**ARCHITECTURAL DESIGN ASSOCIATES, P.C.
7501 'O STREET, SUITE 105
LINCOLN, NE. 68510**

**LINCOLN HOUSING AUTHORITY
MAHONEY MANOR
LINCOLN, NEBRASKA**

ADDENDUM #2

REF. SHT# C1.3

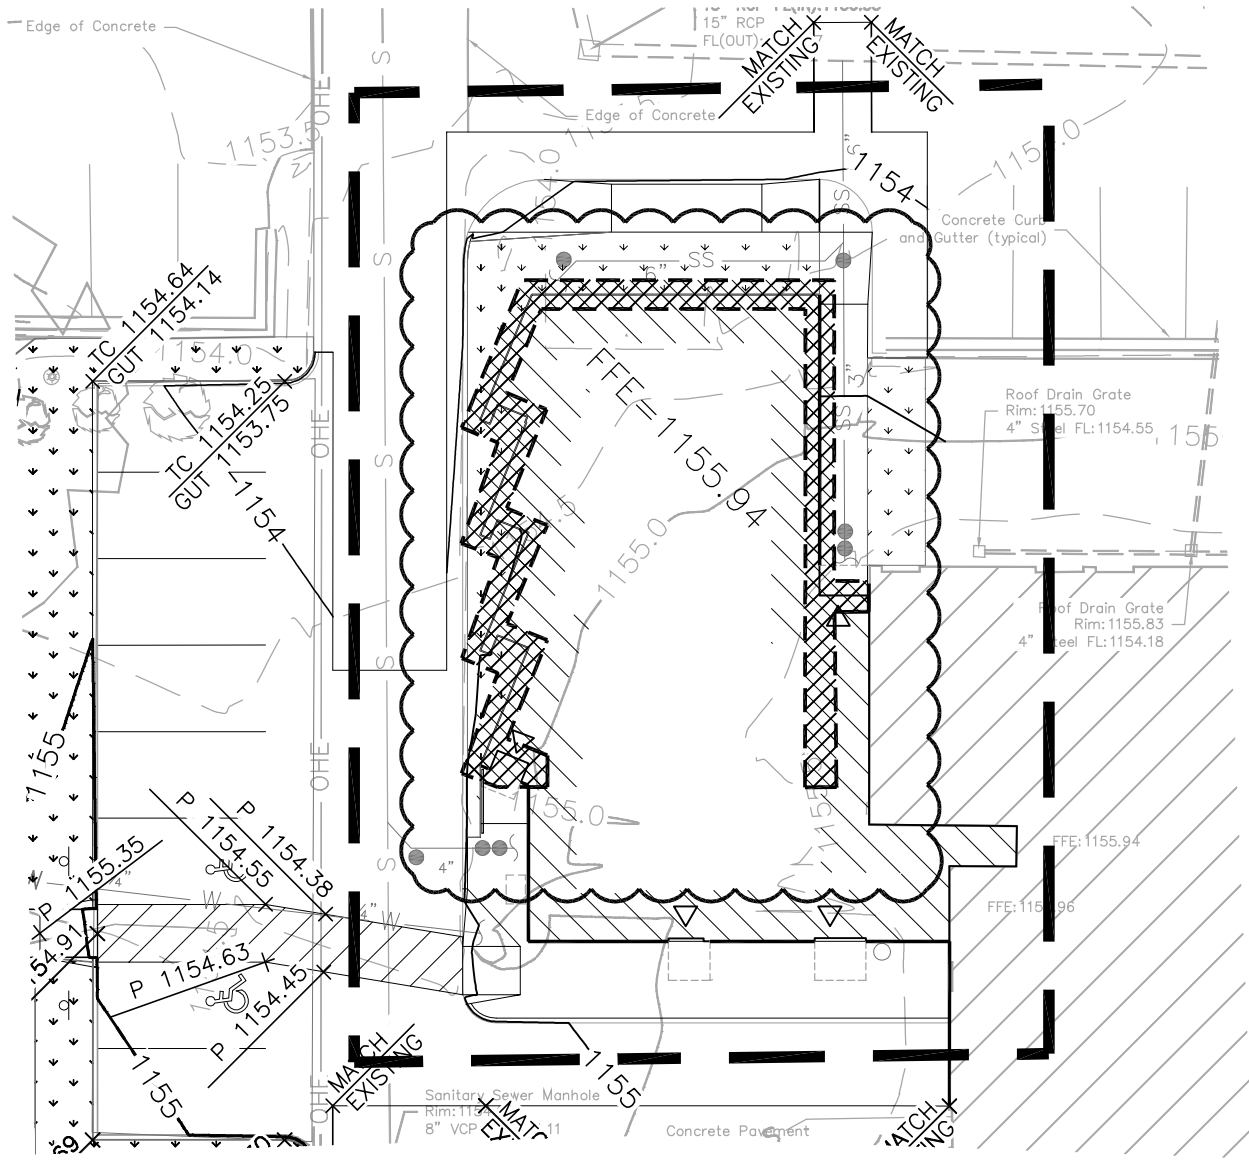
- A. At the Grading Plan and the Enlarged View #2, disregard the over-excavation hatch shown at the Community Room Addition. Instead, add the attached partial grading plan from sheet C1.3, clarifying the extent of the over excavation required at structural footing areas north of Column Line ‘D’.

- B. At the 'Legend', disregard the over-excavation hatch and note and add a note to see the attached partial grading plan from sheet C1.3.
- C. At 'Enlarged View 1', add a note to: "See detail 4, sheet C2.2 for location of stair risers and for break in curb."

— OVER EXCAVATE FOOTINGS TO A DEPTH OF 1145.94 NORTH OF COLUMN LINE 'D' AND FILL WITH FLOWABLE FILL TO BOTTOM OF FOOTING ELEVATION. SEE STRUCTURAL PLANS FOR FOOTING LOCATIONS AND ELEVATIONS, AND GEOTECHNICAL REPORT FOR MORE INFORMATION.

REF. SHT# C1.4

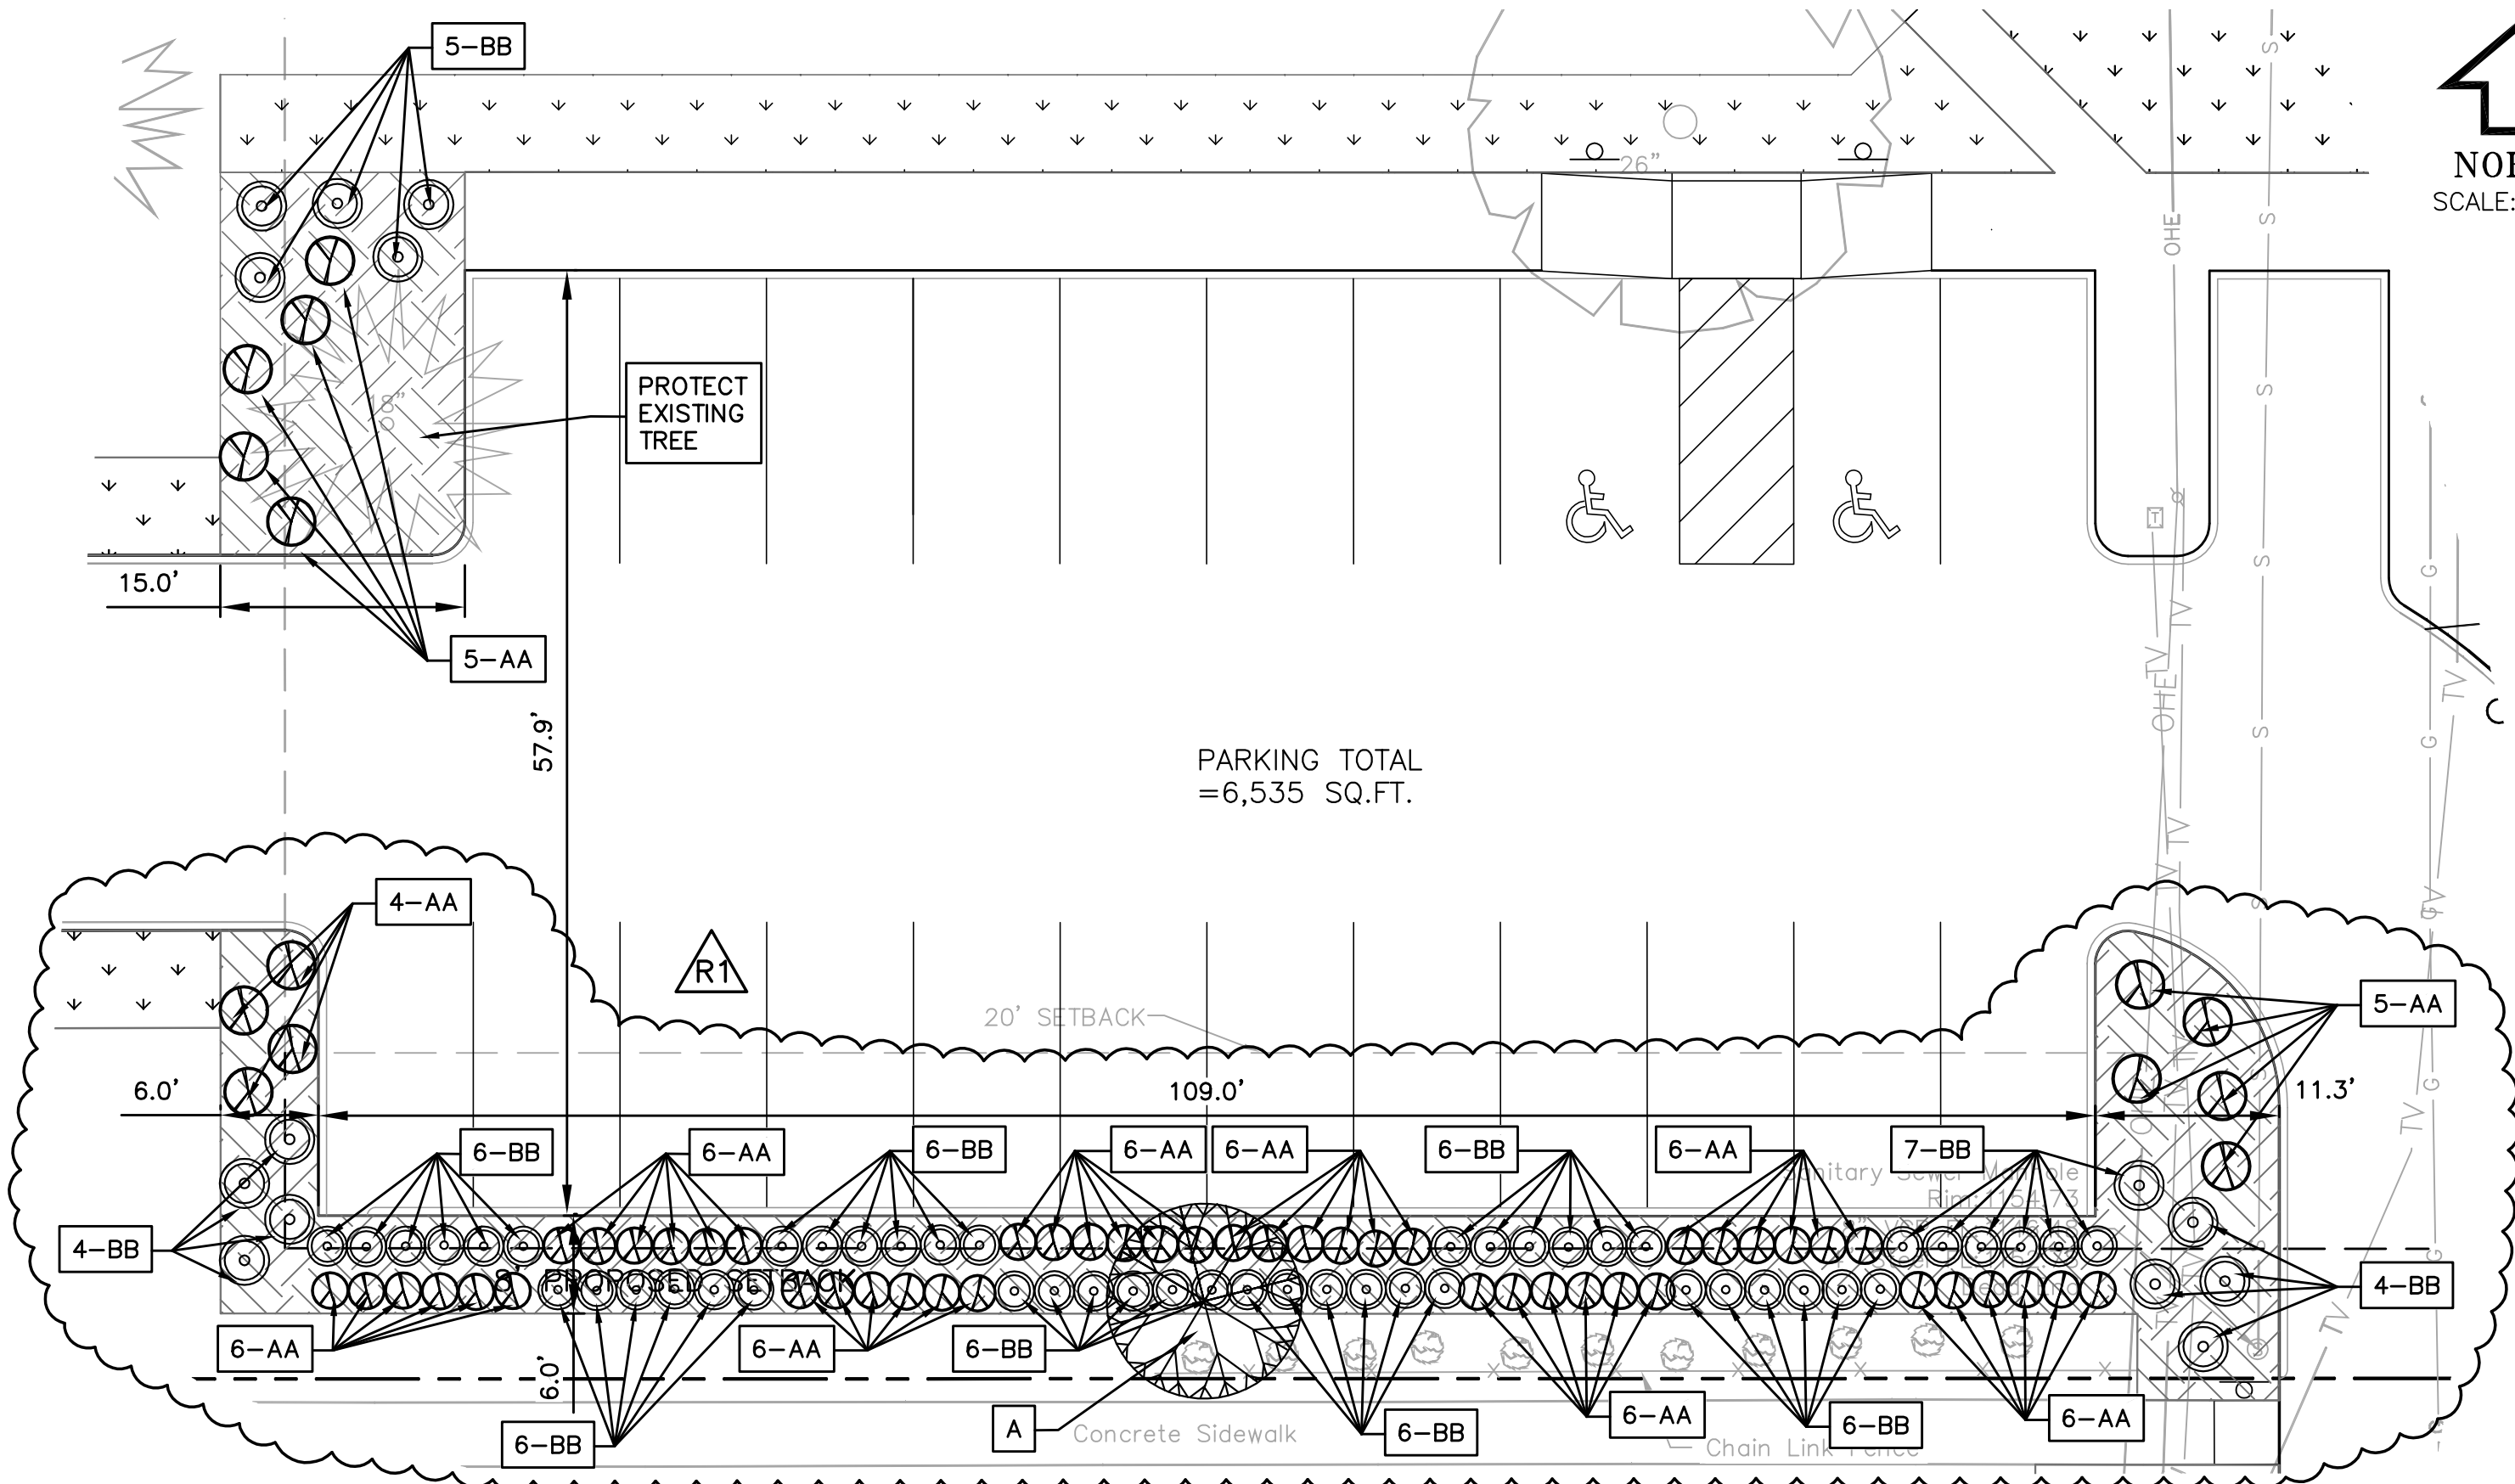
- A. Delete the S.W. Parking Lot Landscaping Plan and the Landscape Schedule and substitute the attached S.W. Parking Lot Landscape Plan and Landscape Schedule from sheet C1.4.
 - a. Also, add a note that the landscaping is to be in the base bid and is to be deleted by Alternate No. 2.

ISSUED FOR:	DATE:	BY:
REVISED LANDSCAPE LAYOUT, REVISED TOTAL COUNT ON LAYOUT SCHEDULE.	08/20/14	SDB
